Notice of Allowability	Application No.	Applicant(s)	
	10/049,252	SCHENK, HEINRICH	
	Examiner Habte Mered	Art Unit 2616

EXAMINER'S AMENDMENT

FIG 1

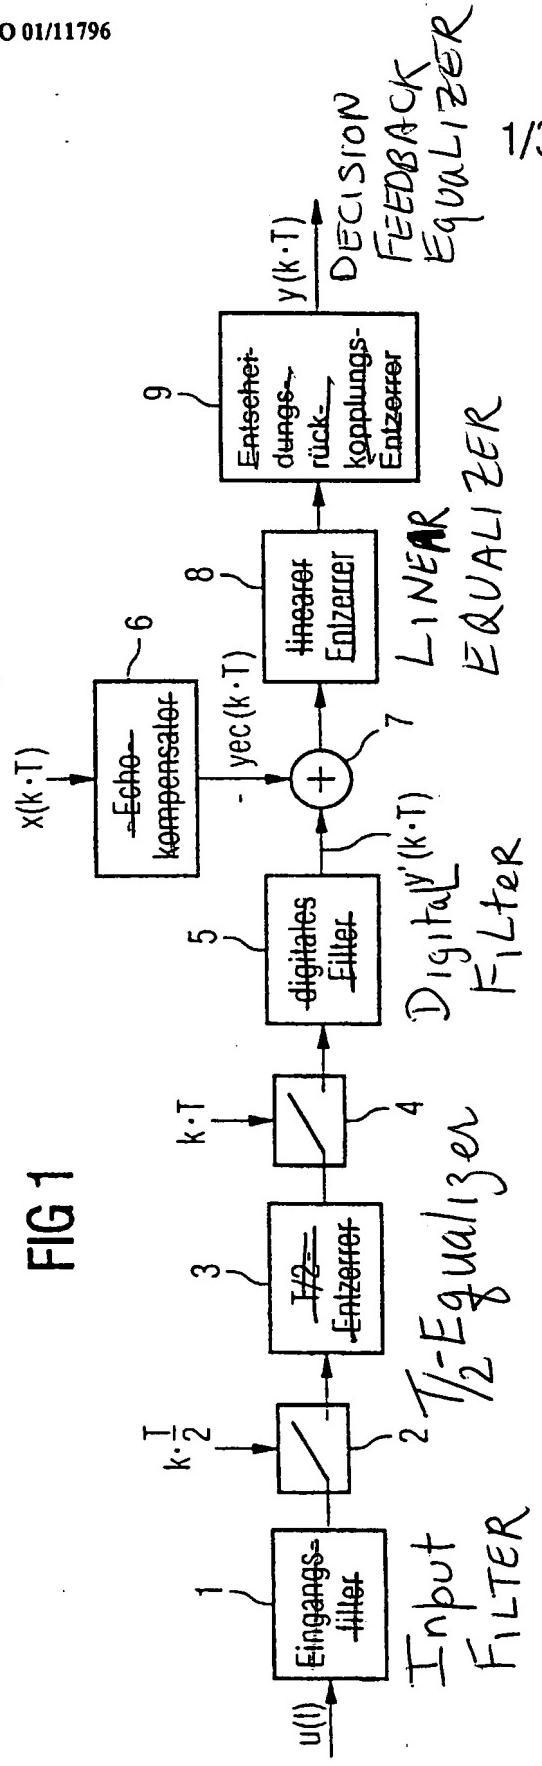
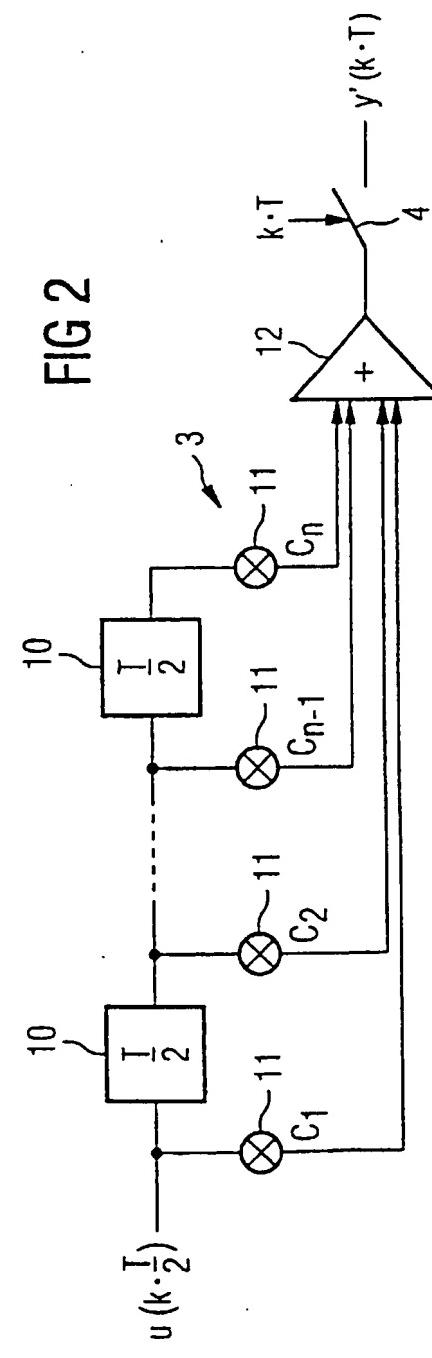
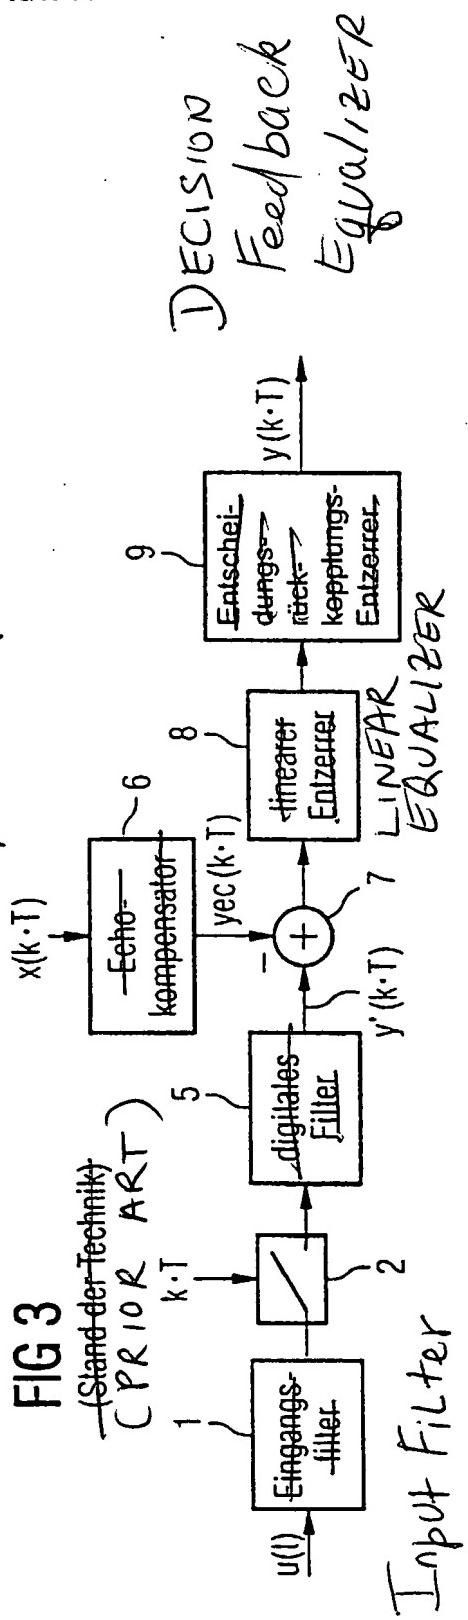
5. The drawings filed on 06/03/2002 are objected to because the labels used in the Figures are German and need to be translated into English. Examiner has provided as Attachment A to the Applicant to provide a frame of reference on how different elements in Figures 1-5 should be labeled. Corrected drawing sheets in compliance with 37 CFR 1.121(d) are required in reply to the Office action to avoid abandonment of the application. Any amended replacement drawing sheet should include all of the figures appearing on the immediate prior version of the sheet, even if only one figure is being

Echo Compensator
